TRUCK UTILITY LT GS SERIES 3 LANDROVER, ALL TYPES
PINTLE HOOK LOCKING LATCH
MODIFICATION INSTRUCTION

Issue of this instruction is authorized by the CONMEA.

FIG 1 - LOCATING COTTER PIN INCORRECTLY POSITIONED
HOLDING THE LOCKING LATCH FULLY DISENGAGED

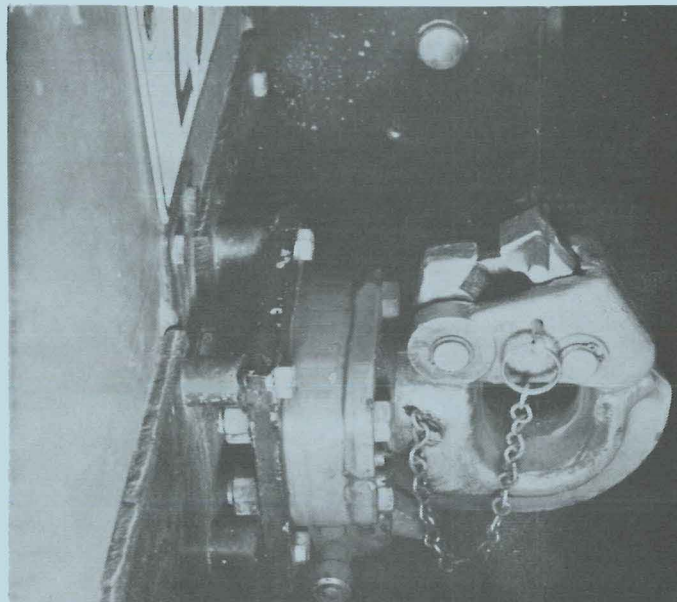
1. This instruction details the reworking of the pintle hook locking latch to prevent the locating cotter pin being inserted on the under side of the locking latch. Figure 1 shows this defect.

FIG 2 - WELD BUILD-UP ON LOCKING LATCH

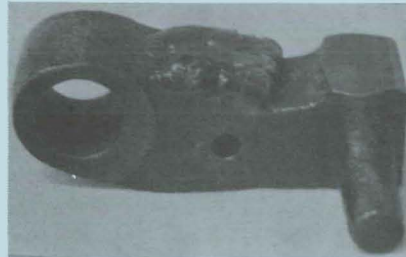
7. To carry out the modification proceed as follows:
 - a. Remove the locking latch from the pintle hook.
 - b. Using a suitable mild steel electric welding rod, build up the locking latch area directly below the locating cotter pin hole to a height of 5 mm, as shown in Fig 2. Ensure the built up area extends the full width of the locking latch.
 - c. Dress up the weld area as shown in Fig 3, do not remove more than 1 mm of weld height.
 - d. Paint the reworked area in accordance with WKSP B 700.
 - e. Refit the locking latch to the pintle hook. Ensure that the locating cotter pin cannot be inserted on the wrong side of the latch.
